# SERVICE BULLETIN #125

04/14/14

## 9660 Spoke Wheel

### Obsolete Part

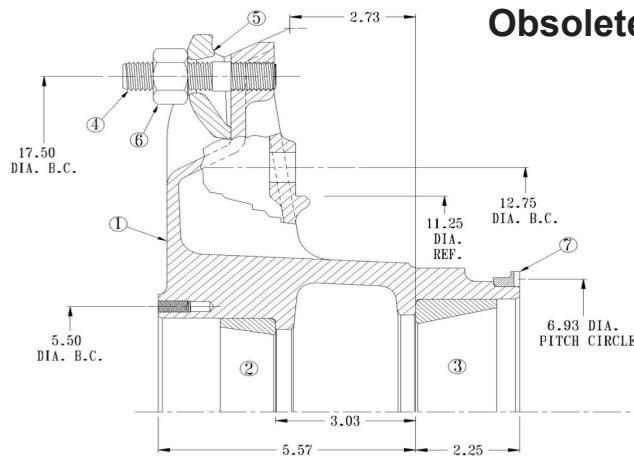
Upon depletion of inventory, the 9660 spoke will become obsolete with no direct replacement. We do however recommend a replacement: the 10-stud 2530 hub. This requires changing brake drums, changing to a disc hub, and changing to disc wheels instead of demountable rims. If you have any questions, please contact the Webb Engineering department via email to [engineering@webbwheel.com](mailto:engineering@webbwheel.com) or call 256-736-6356.
